## CVS Distribution Center Chiller Equipment, Screen Wall and Parking Lot SP 10-09

**CVS Distribution Center Chiller Equipment, Screen Wall and Parking Lot  
SITE PLAN NO. 10-09**

## PLANNING REVIEW

## PLAN REVIEW CENTER REPORT

**ROOF TOP EQUIPMENT PICTURES**

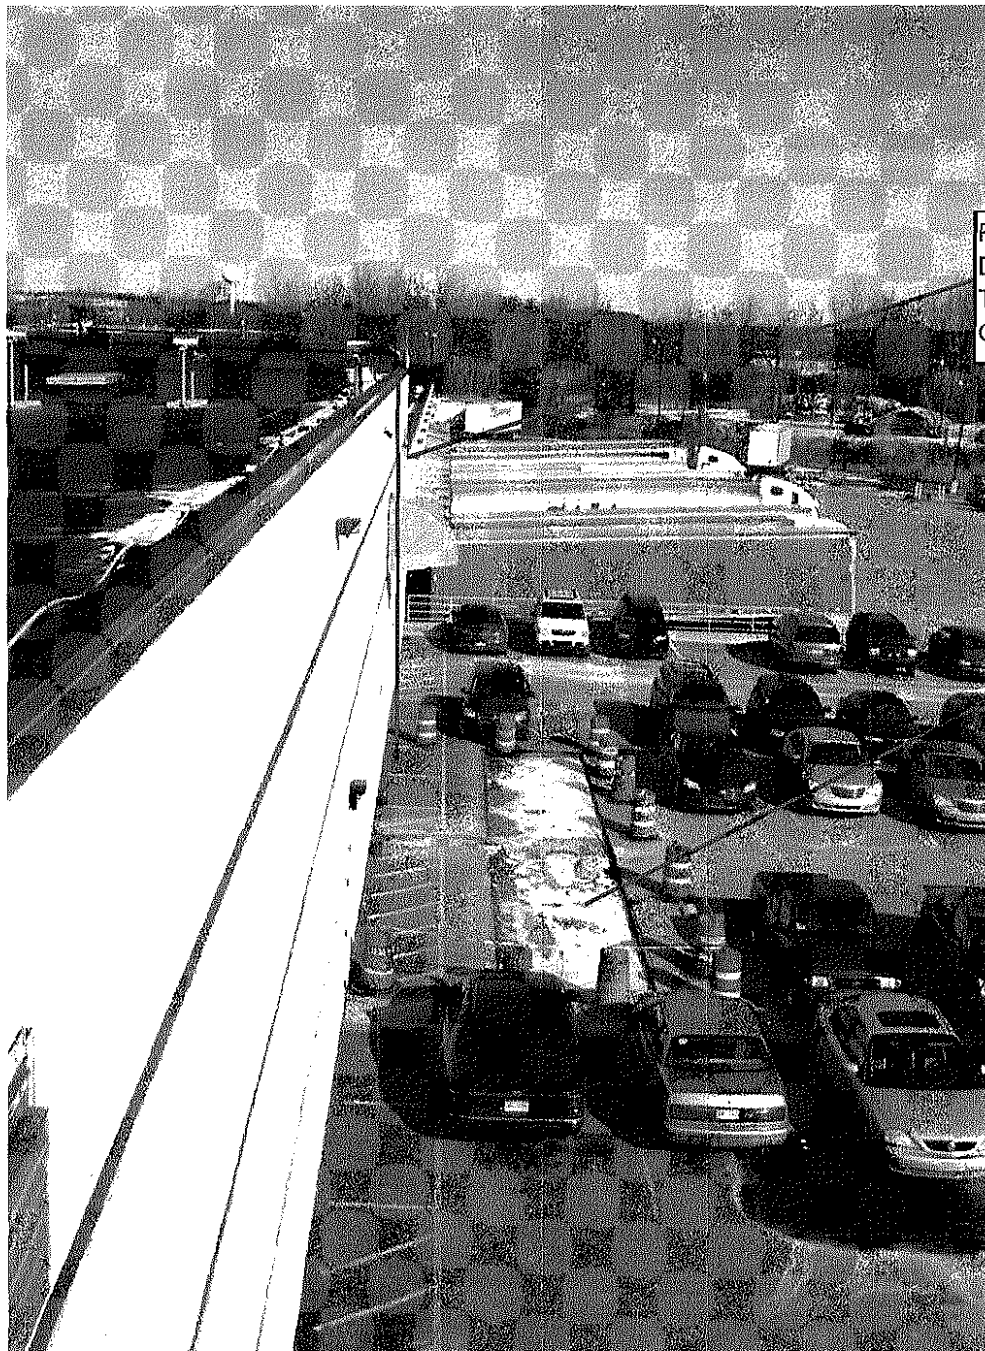
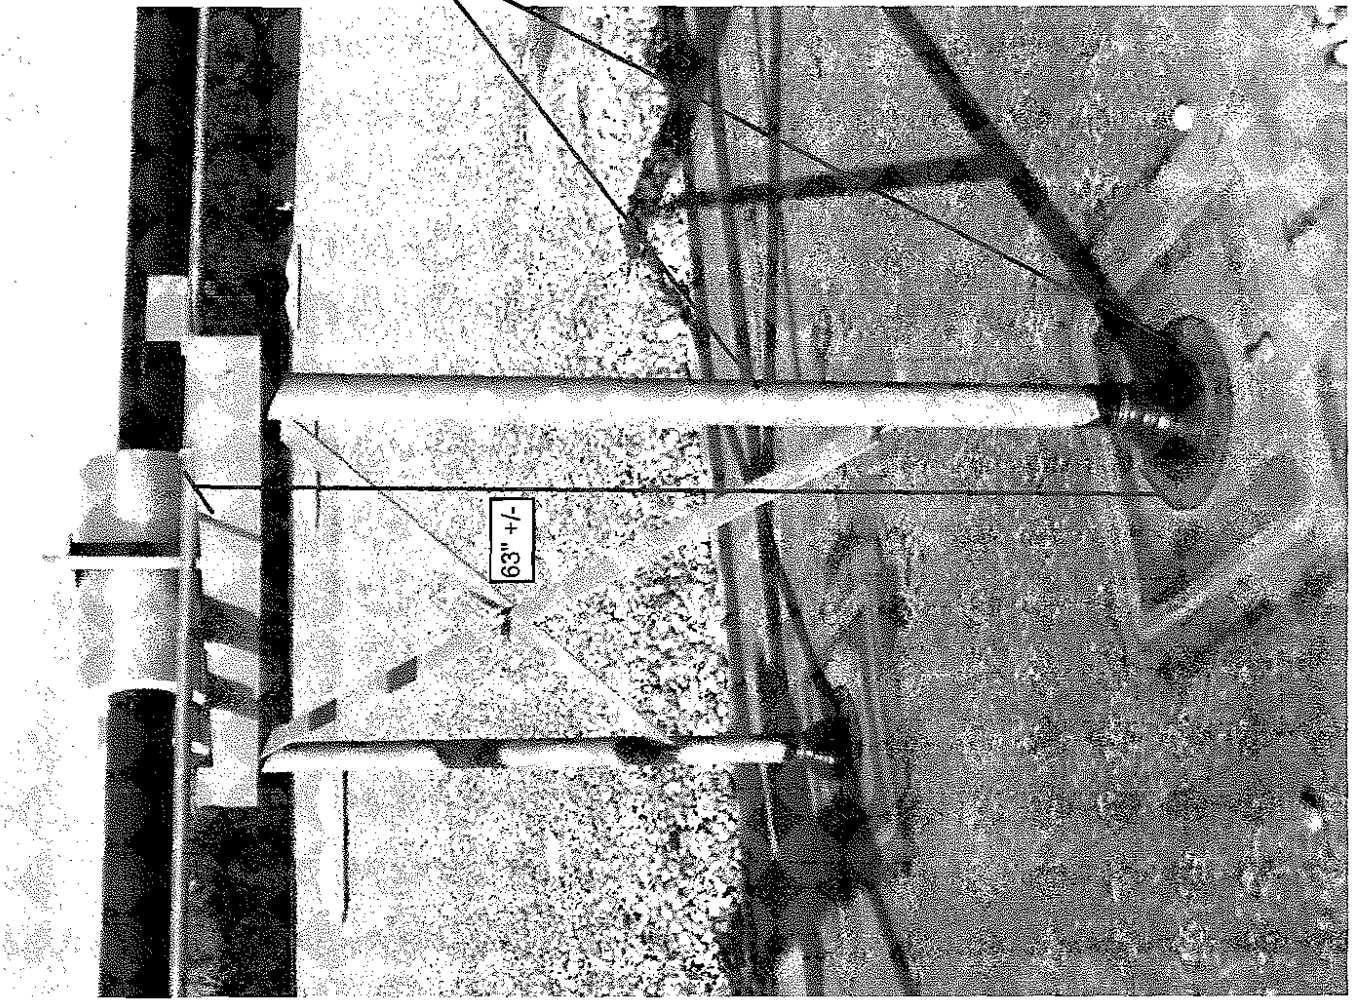
- 4. Roof Top Equipment** (Section 2503) *The Zoning Ordinance requires all roof top equipment to be less than 5 foot high and screened from view of the neighboring properties. The applicant is proposing to place on the roof a network of piping to support the cooling system. They proposed to mount it 63 inches off of the roof and do not propose any screening. The applicant is asked to **remove or lower and screen the piping or obtain a variance from the Zoning Board of Appeals.** The Planning Staff supports a variance since the pipes are only 6 inches in diameter and as designed would be less visible and intrusive in appearance than the typical sheet metal screening that is usually installed to screen roof top appurtenances.*

PIPES WILL BE EXTENDED  
DOWNWARD ALONG THE WALL  
TO CONNECT TO CHILLER UNIT  
GC-1

PROPOSED CHILLER  
UNIT LOCATION

- At West Property Line

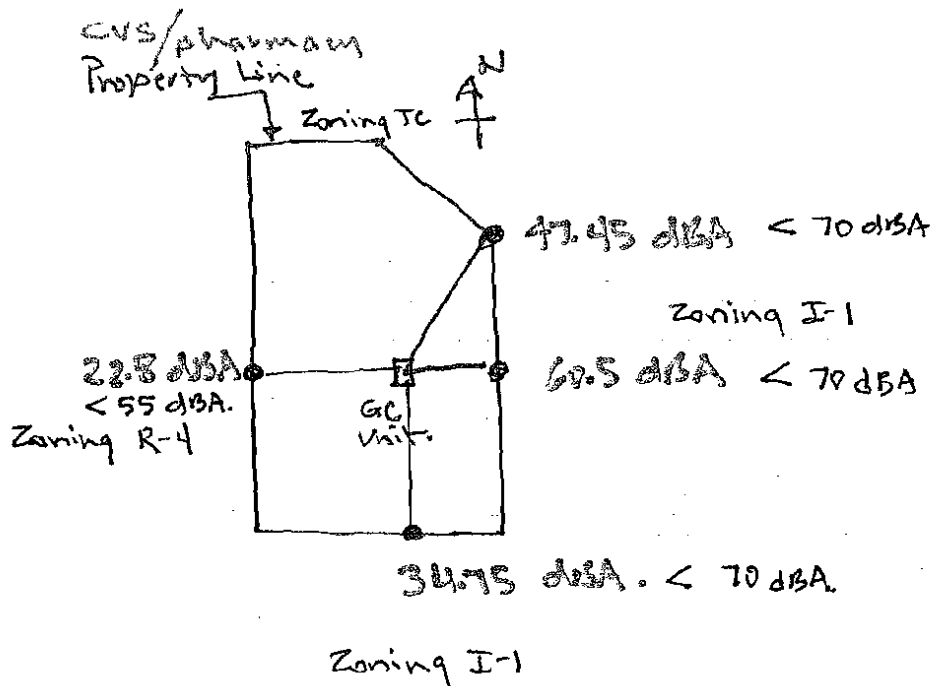
1. *Provide a noise impact statement prepared in accordance with Section 2519.10.c.i. Your manufacturer's sheets contain all of the information, but you need to present it into a short narrative. Example the 400 high emits xx dbs at 30 feet. Providing a sound wall reduces this by xx dbs. And being xx feet to property line reduces this another xx dbs. State hours of operation (24?)*

There are two building walls between chiller unit and the property line. Reading reduces by 10 dBA for each wall.

$$\begin{aligned}
&= 68 - 10 \times 2 - \left( \frac{504}{100} \right) \times 5 \\
&= 68 - 20 - 25.2 \\
&= 22.8 \text{ dBA.}
\end{aligned}$$

CHILLER UNIT AREA LAYOUT  
SCALE: 1"=20'

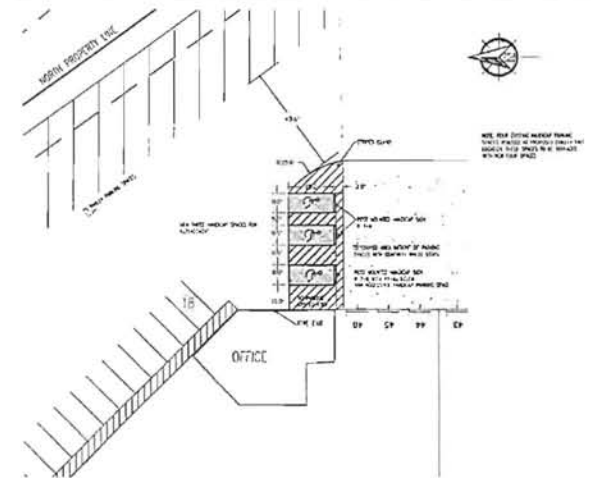
2. **Accessory Structures** (Section 2503) In the I-1 District, accessory structures are required to be placed in the rear yard. The applicant is proposing to place a chiller and screen wall in the side yard. The applicant is asked to **relocate the chiller or obtain a variance from the Zoning Board of Appeals** to place the chiller in the proposed location. The *Planning Staff supports this variance* since the location is the most screened from the neighboring residential properties and will offer the most noise attenuation because the warehouse building will block most of the sound from the chiller from reaching the neighboring residential properties.

PROPOSED HANDICAP PARKING LAYOUT NEAR OFFICE  
SCALE: 1"=20'

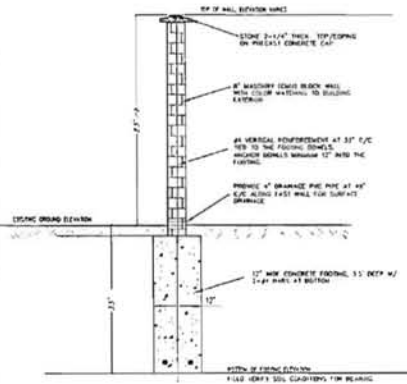
*The applicant has provided six barrier free spaces but Michigan Barrier Free Code requires seven parking spaces. The applicant is asked to provide one additional barrier free space.*

PROPOSED LANDBANK PARKING, TYPICAL DIMENSIONS  
SCALE: 1"=20'

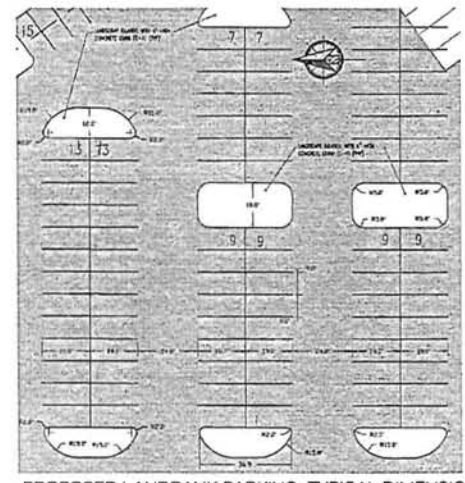
3. *The proposed land banked parking shows that underground detention would be proposed if additional parking is required. If this ever came up, a separate detailed site plan would need to be submitted and any additional impervious area would need to be detained for the 100-year storm volume.*

**If in future the parking area expansion occurs, a revised site plan addressing the detention requirement will be submitted to the City for approval.**
